ADDENDUM # 1

7/23/14
Solicitation #7548863

Title: Provide Site Improvements at the Knight Campus Baseball Field

Pre-Bid Questions and Concerns

SKL-001	
REF DWG:	S-1

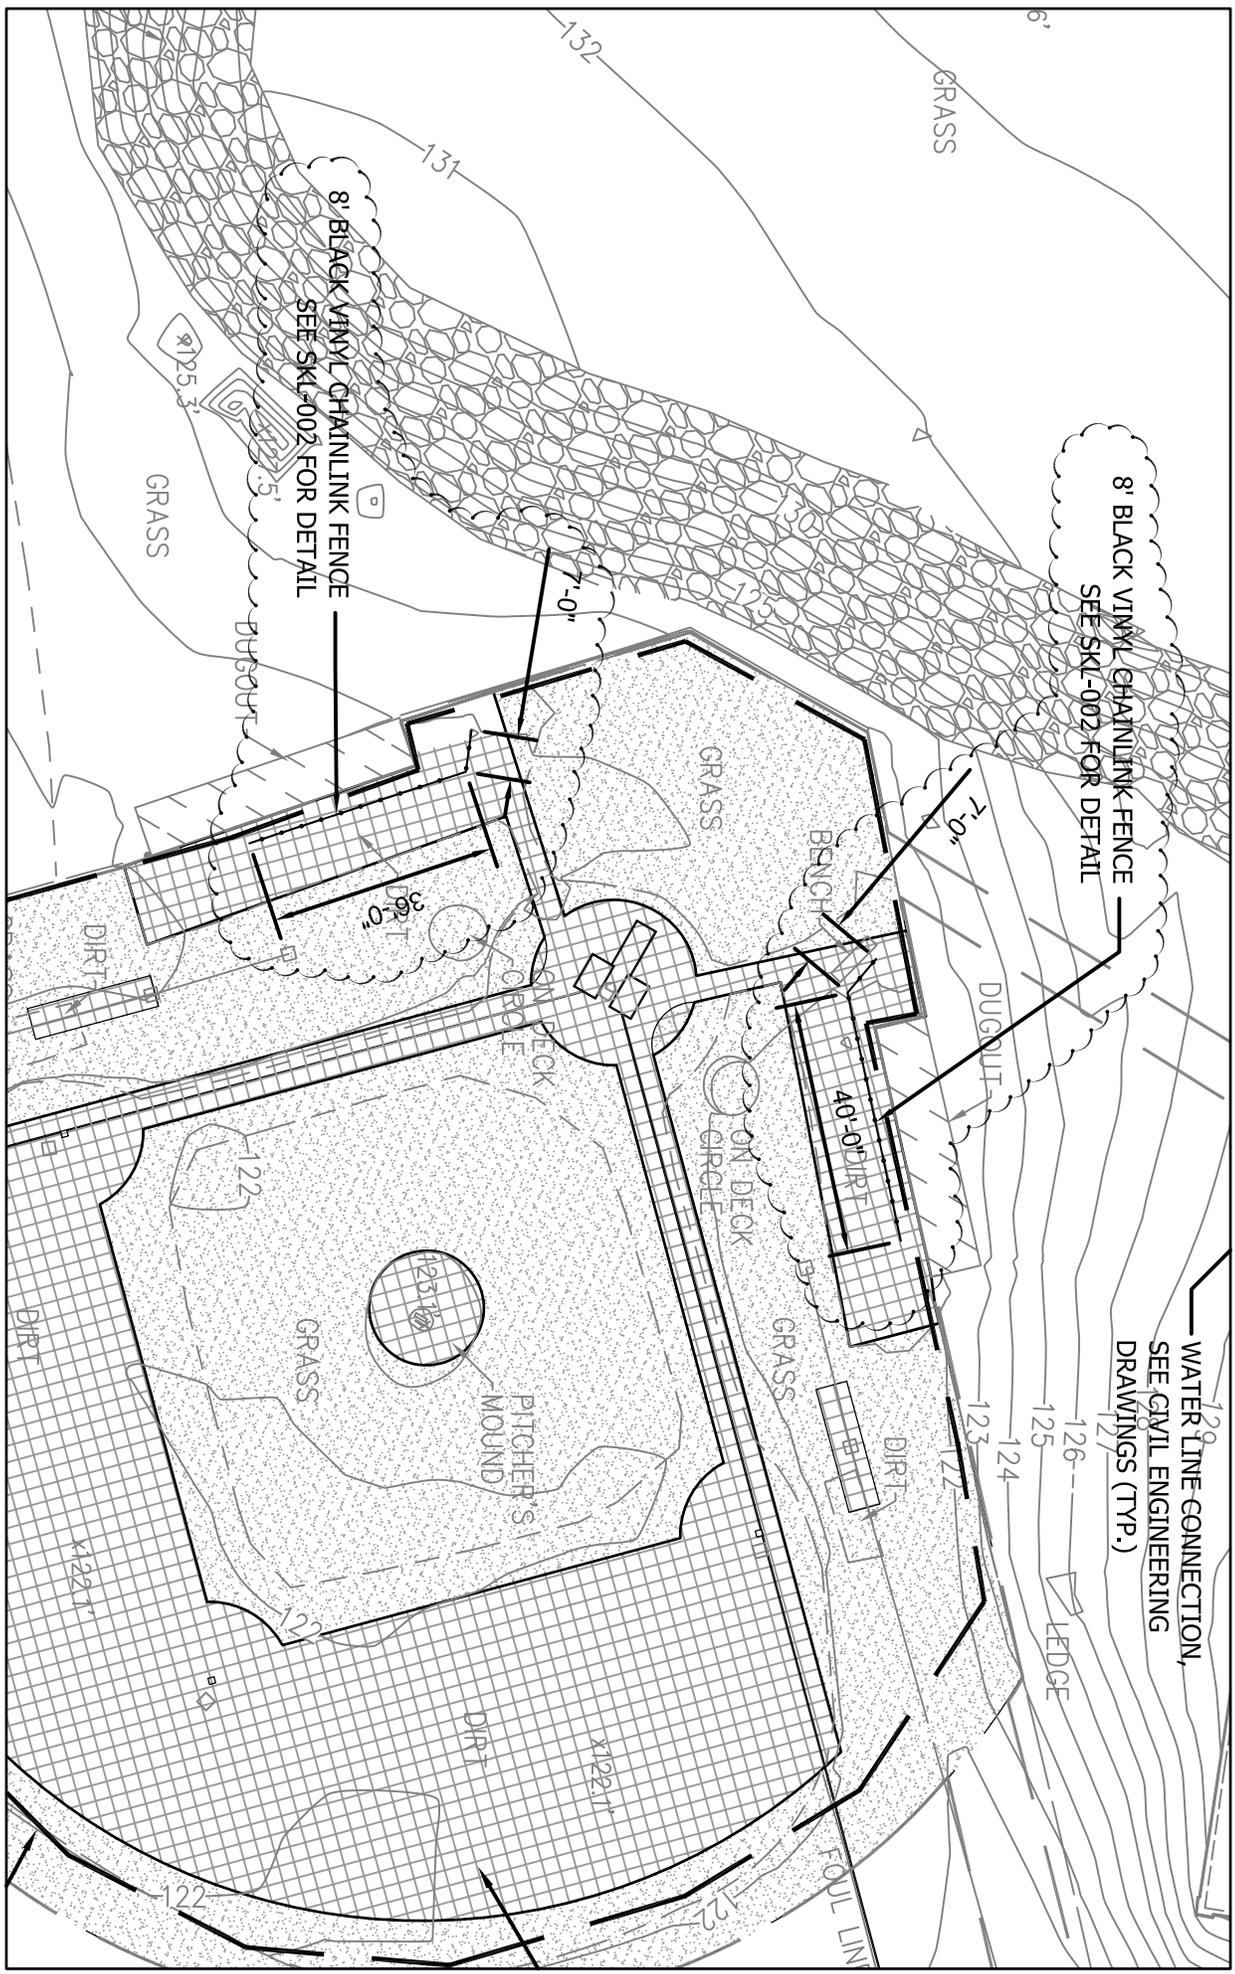
Foundations of fence (dugout areas) exposed out of the ground. How will this be corrected? Is new fencing being installed?

Response: Per the owner's request, new black vinyl chain link fence, posts ,and foundations directly in front of the dugouts will be added to the contract as detailed in SKL-001 and SKL-002.
